# City of Portland Design Commission

## Design Advice Request

### SUMMARY MEMO

**Date:** December 5, 2023  
**To:** John Holmes, GUNA Collaborative  
**From:** Tim Heron, Design / Historic Review Team  
(503) 823-7726, [tim.heron@portlandoregon.gov](mailto:tim.heron@portlandoregon.gov)  
**Re:** EA 23-090643 DA – 3606 NE MLK Jr Boulevard Apartments  
Design Advice Request Commission Summary Memo – November 16, 2023

### **5. Adjustment Ground Floor Active Use**

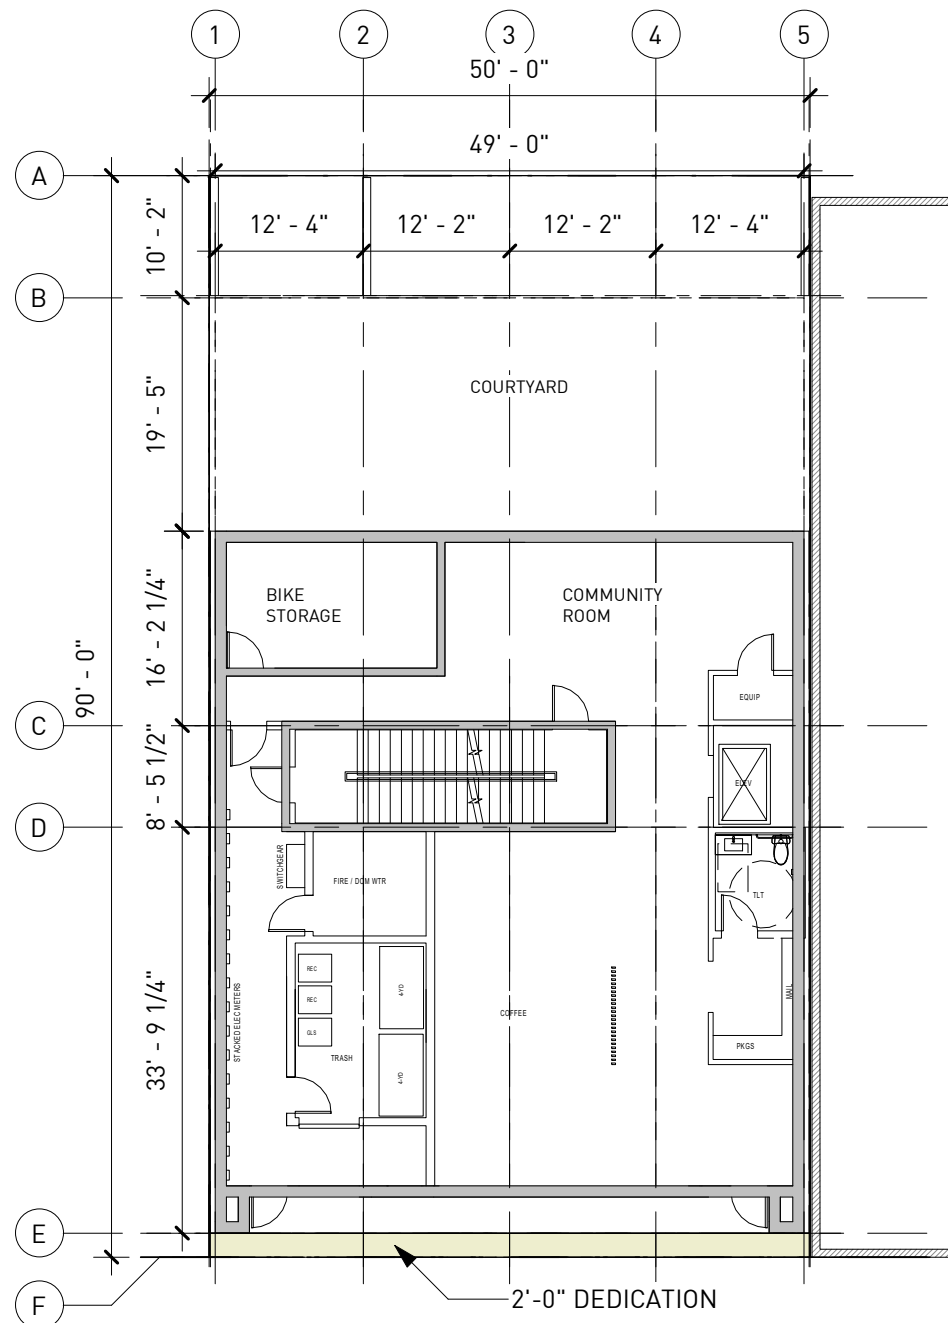
*Note: The Ground Floor Active Use standard may or may not be altered by the ongoing [Housing Regulatory Relief Project \[HRRP\]](#).*

## REQUIRED BIKE PARKING MODIFICATION

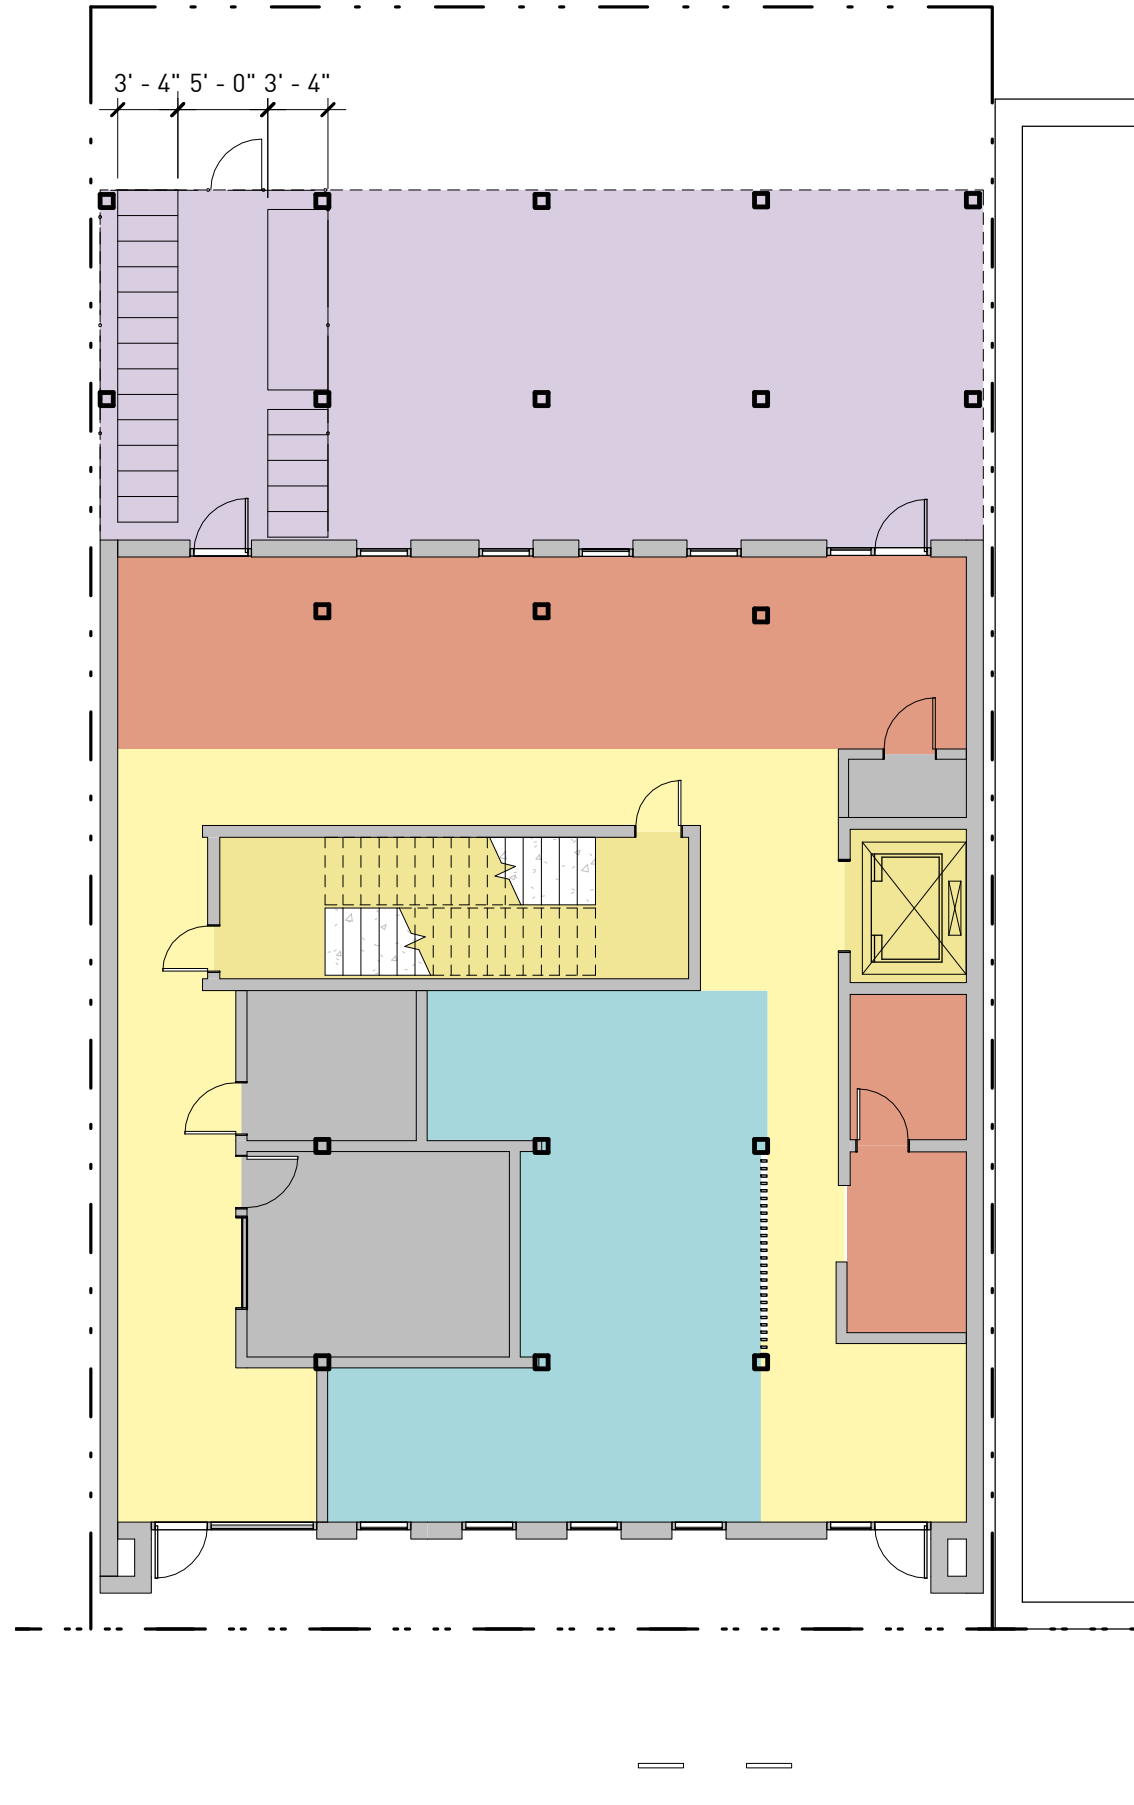
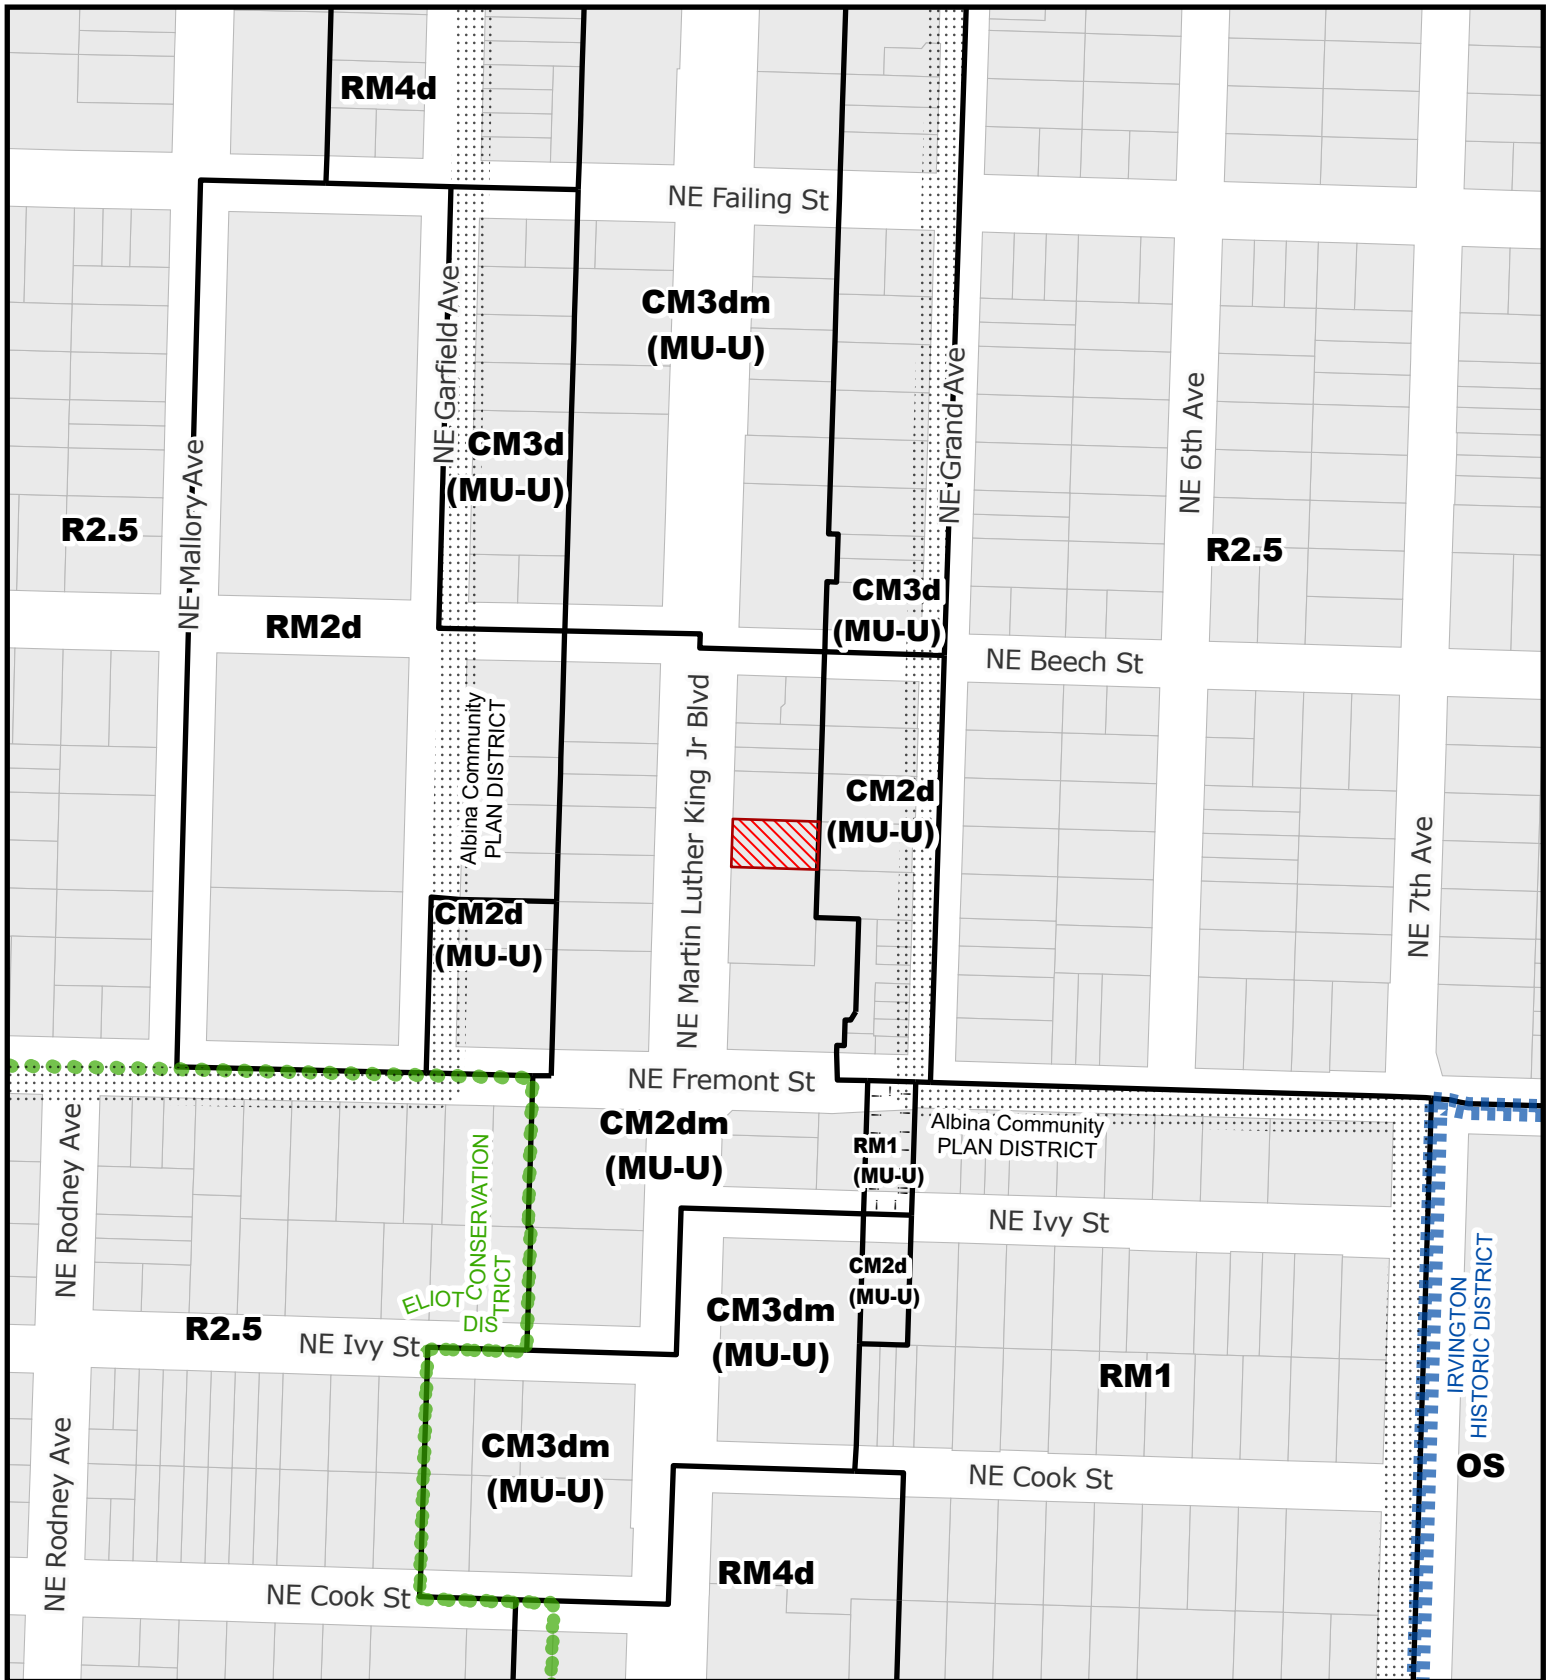
Bike Parking Modification: The applicant has proposed to reduce the number of bike spaces per unit, eliminate the alcove requirement within units, provide all bike parking spaces vertical, and pay into a fund for short term spaces.

PBOT does not support the vertical parking request but does support the remaining three proposed Modifications.

#### 4. Modification to Bike Parking

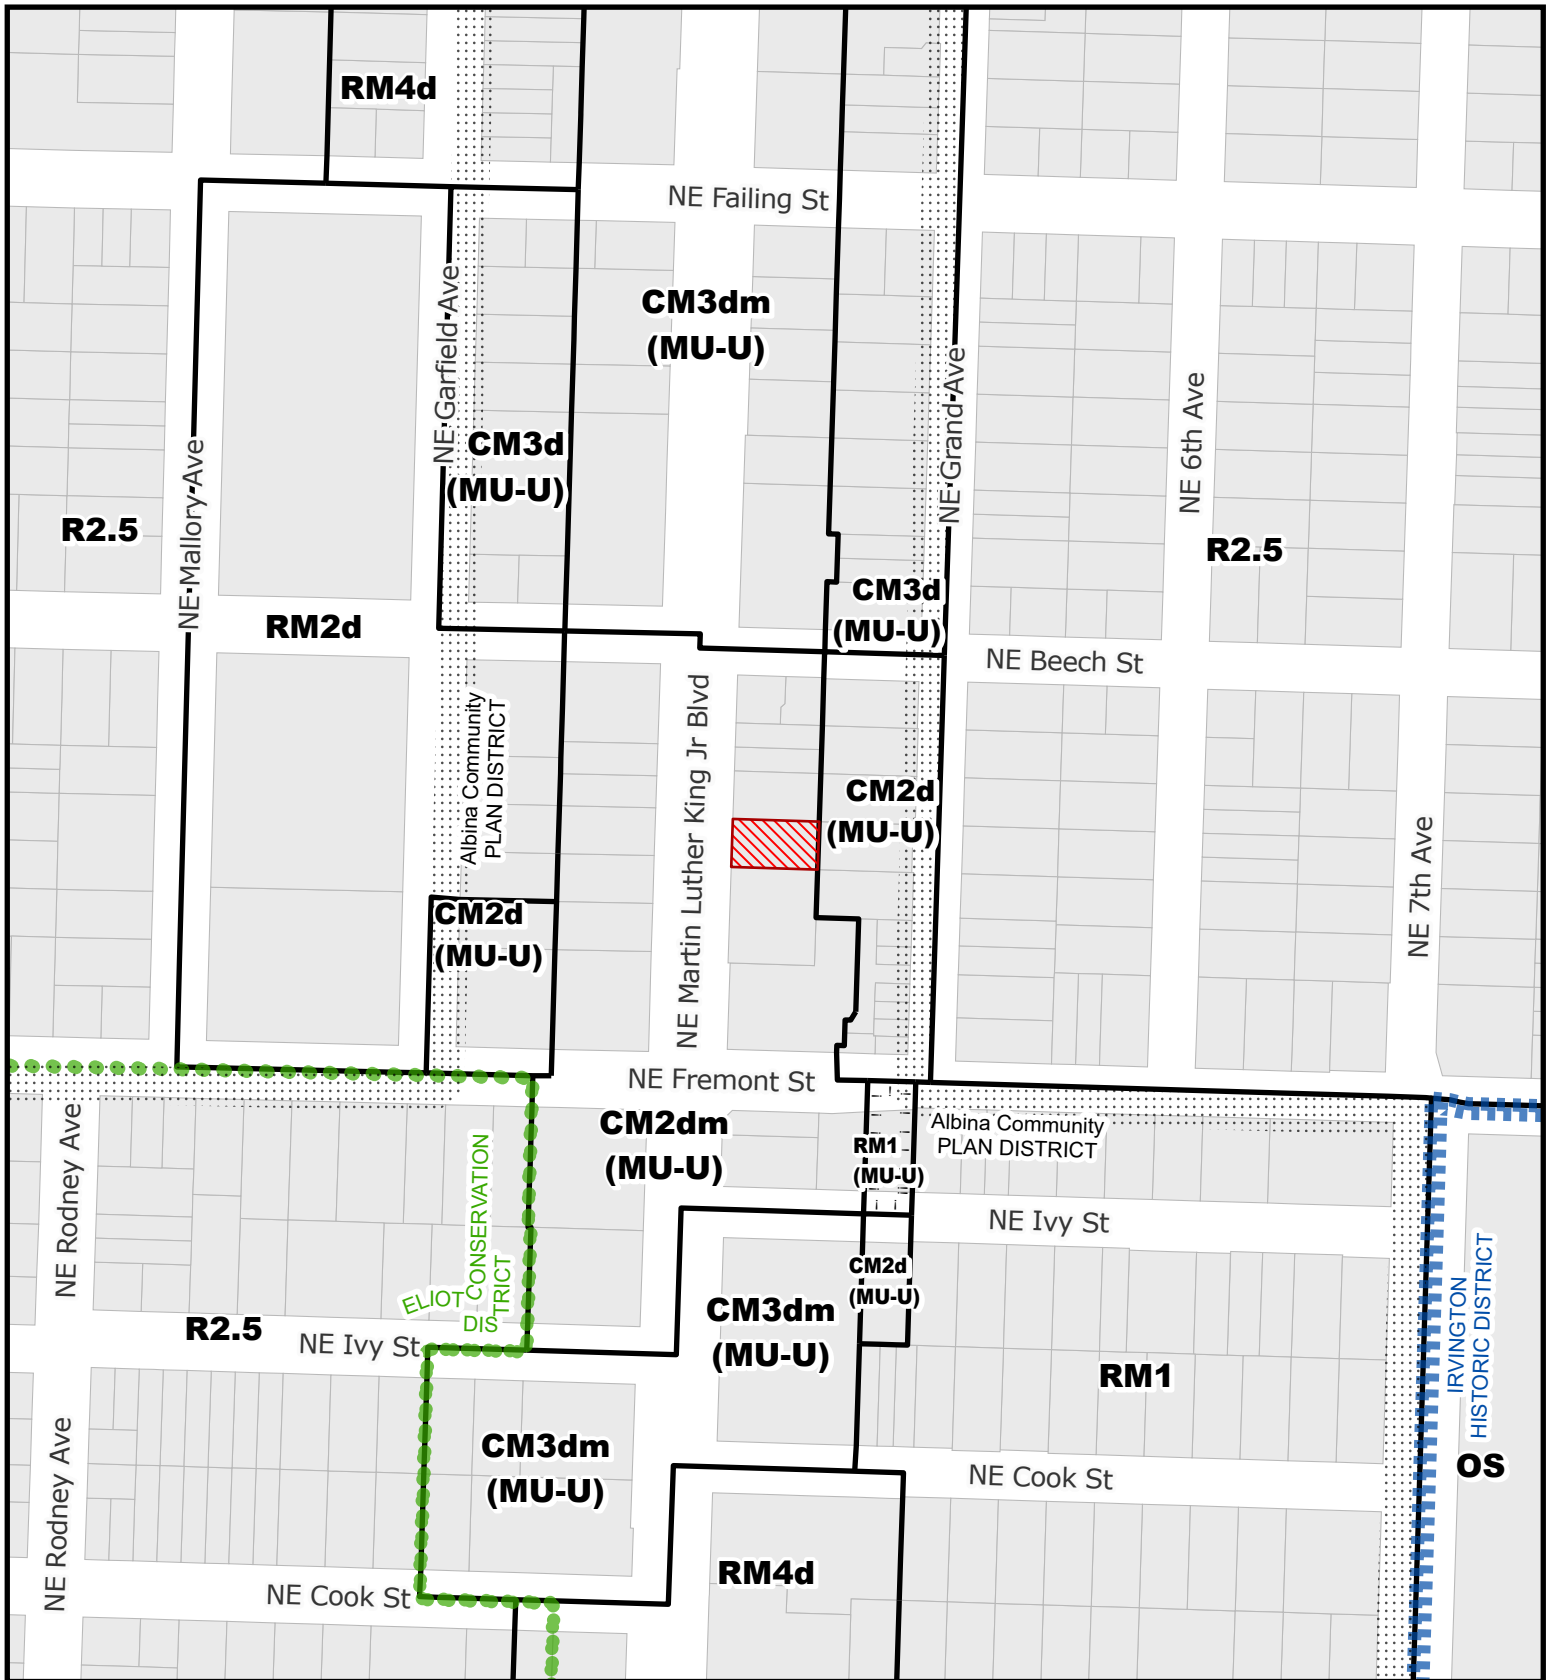
- The Bike Parking standards may or may not be altered by the ongoing [Housing Regulatory Relief Project](#), so consideration of the standard as written is necessary.
- PBOT will be available to speak to the balance between small studio in-unit bike parking both vertically and horizontally, and ground floor bike parking.
